U.S. Department
of Transportation
**Federal Highway
Administration**

In Reply Refer To:
HSA-10/B147A

In your June 7th letter to Mr. Richard Powers of my staff, you requested formal Federal Highway Administration acceptance of a design concept by which your high-tension test level 3 (TL-3) and TL-4 Gibraltar cable rail could be transitioned and connected to a strong-post W-beam guardrail.

GIBRALTAR
TL-3 CABLE
BARRIER
ATTACHMENT
TO GUARDRAIL

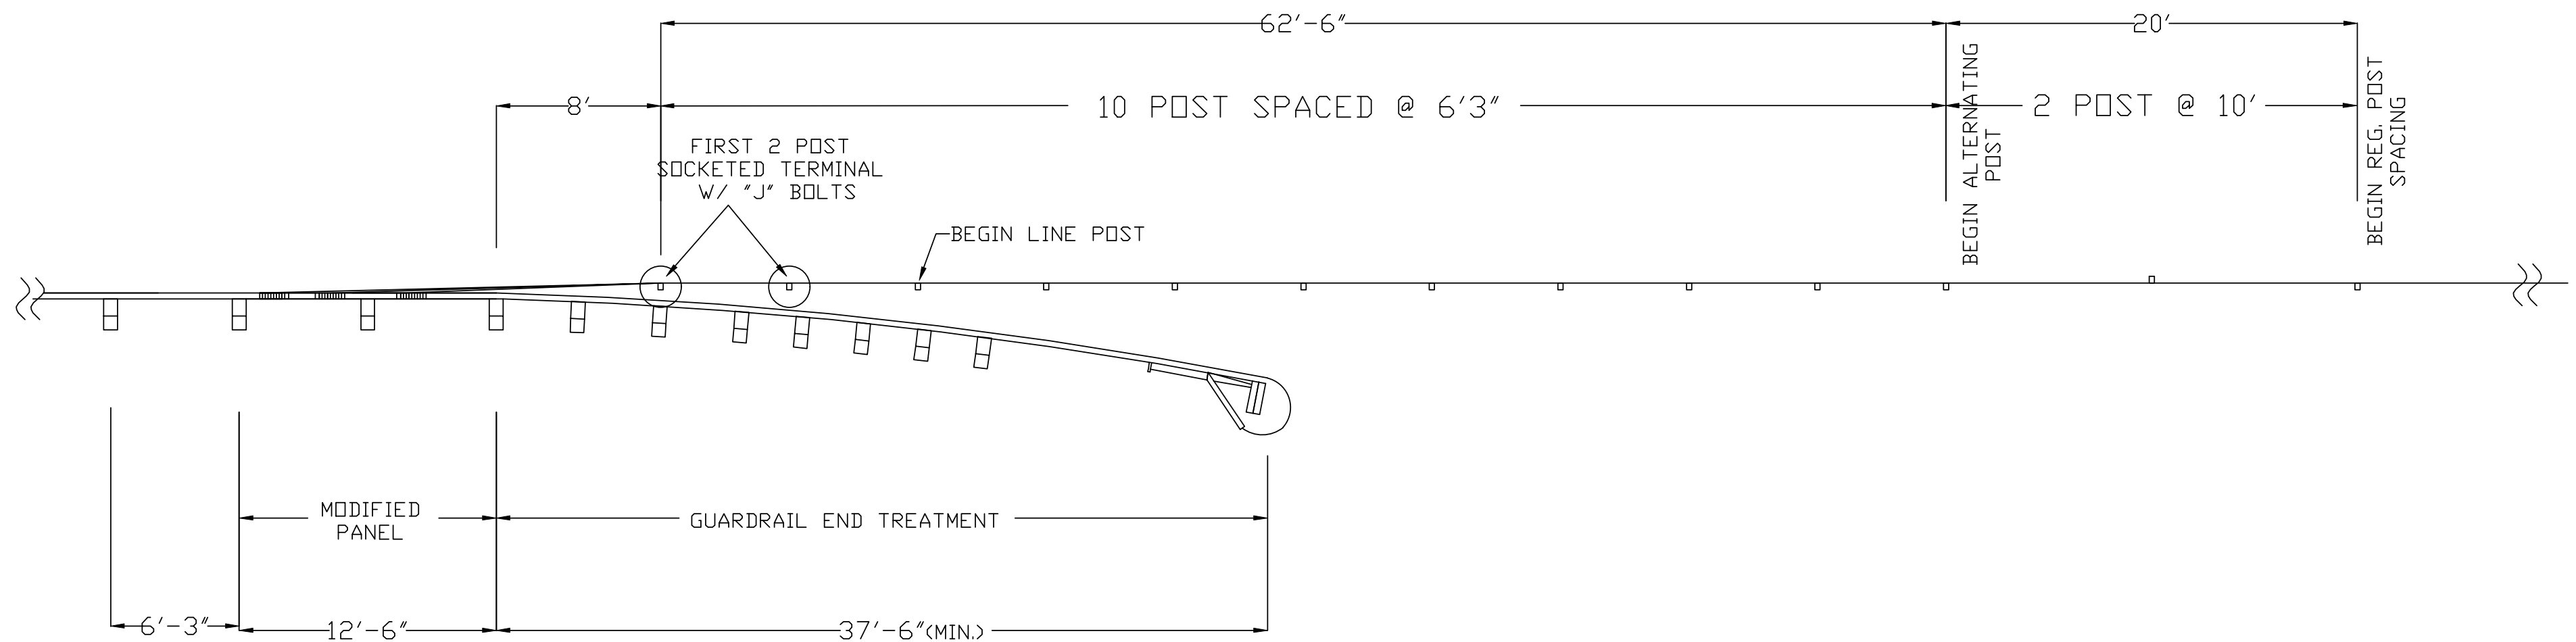
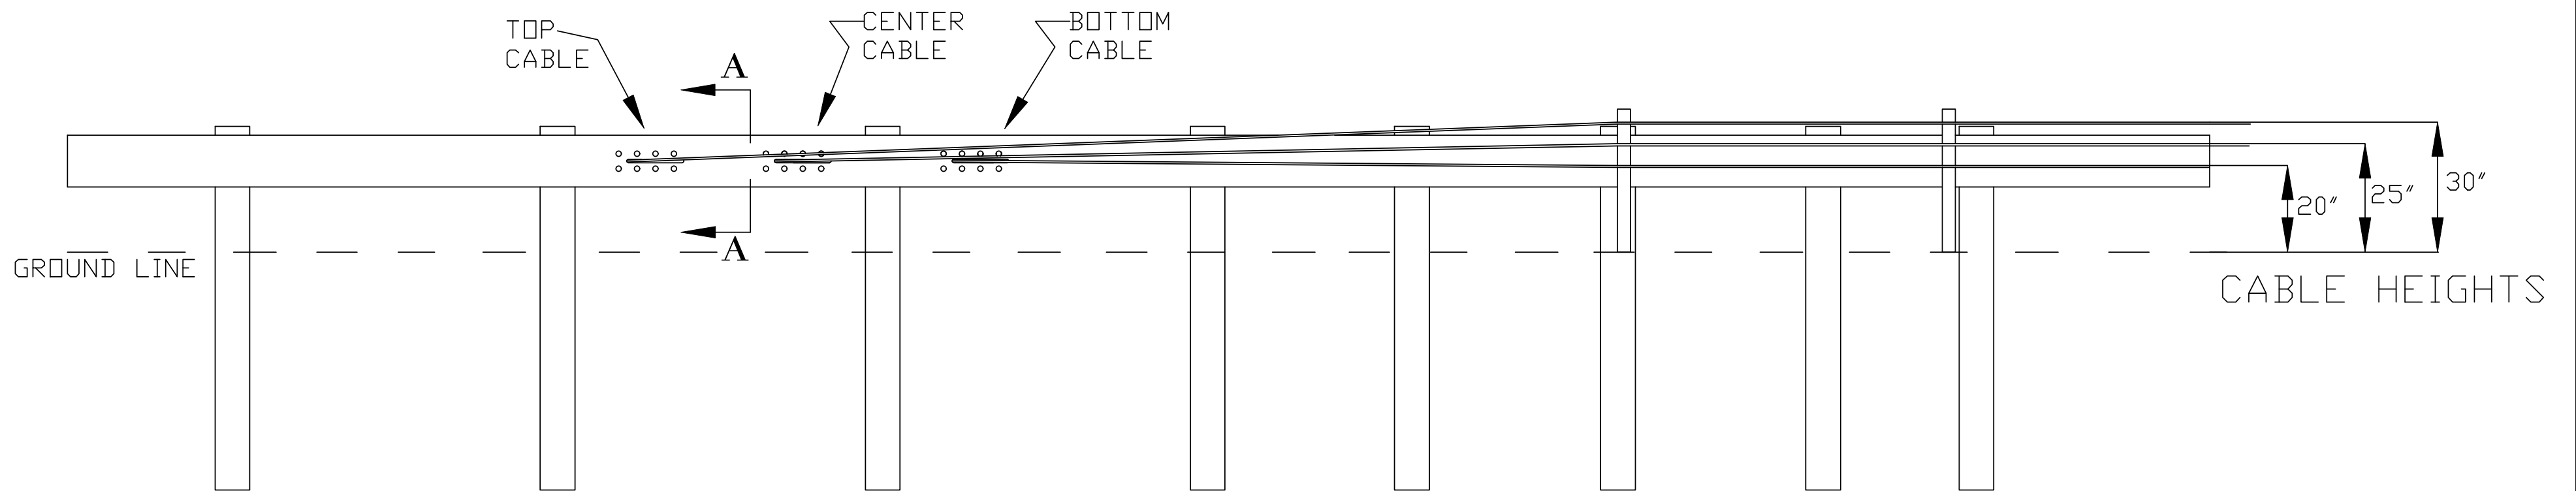
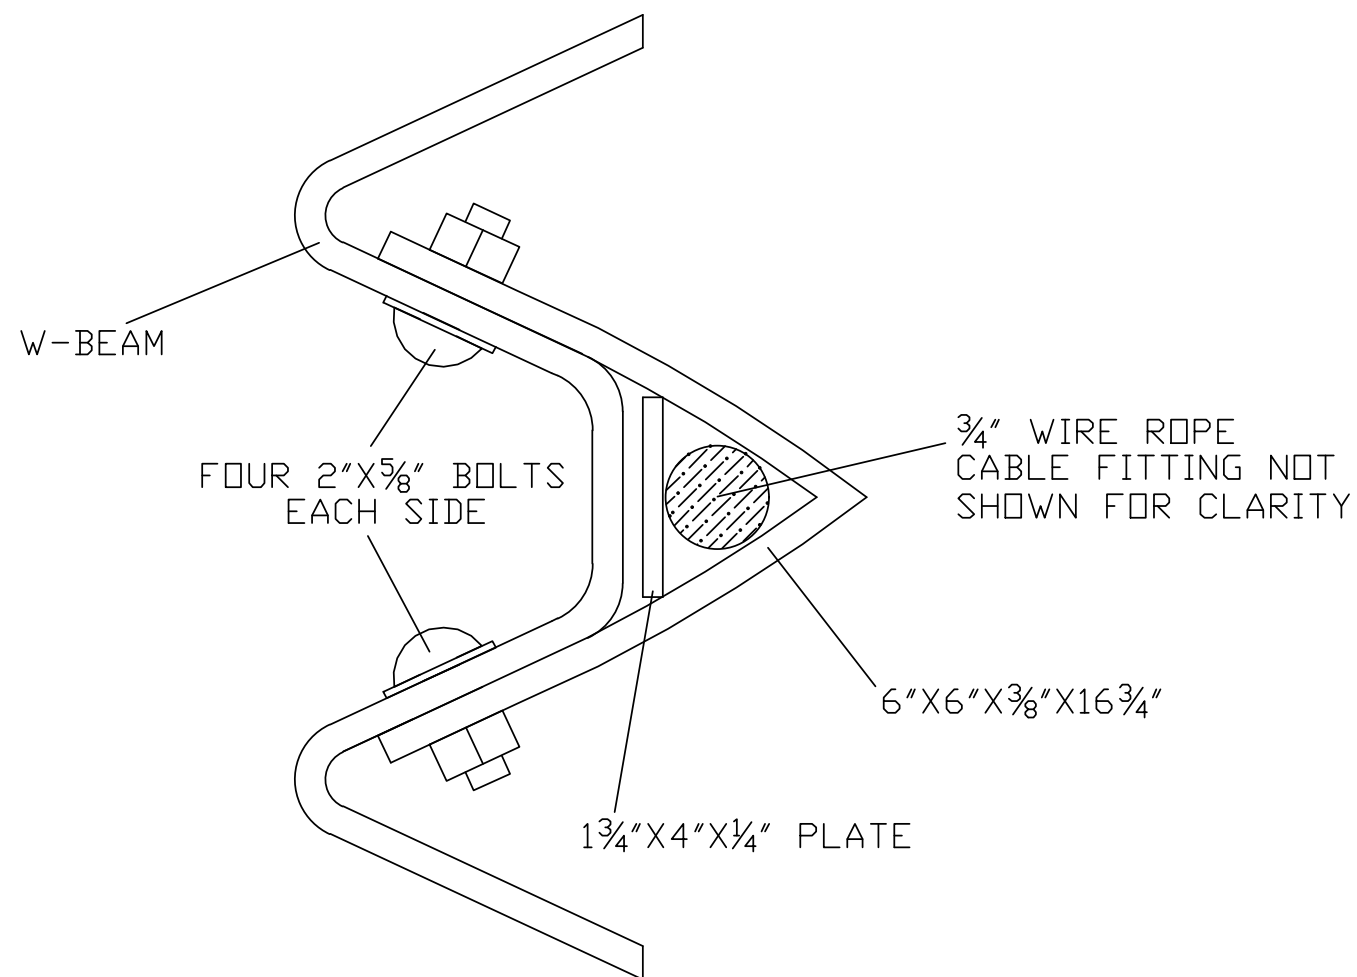
Your transition design is intended for use in conjunction with a W-beam installation that has a standard, crashworthy terminal with a minimum 4'-0" offset from the cable. Each cable is threaded through a 12.75-inch x 1-inch slot in the valley of the W-beam panel and connected to the back of the panel with a modified, commercially-available steel bracket and cable fitting anchor. The first eleven Gibraltar posts are set on 6'-3" centers and all of these posts are behind the cables. From this point, the posts are set on alternating sides of the cables, with the next two posts on 10-foot centers and the remainder on the post spacing selected for the barrier length of need. Details for this transition design are shown in the enclosed drawings.

Based on the specific design details noted above, your proposed transition design is acceptable for use on the National Highway System at National Cooperative Highway Research Program Report 350 test level 3 when used in conjunction with a crashworthy terminal having a

minimum 4-foot offset from the cables. Since this transition design has not been physically tested, field installations should be monitored to verify their presumed crashworthiness.
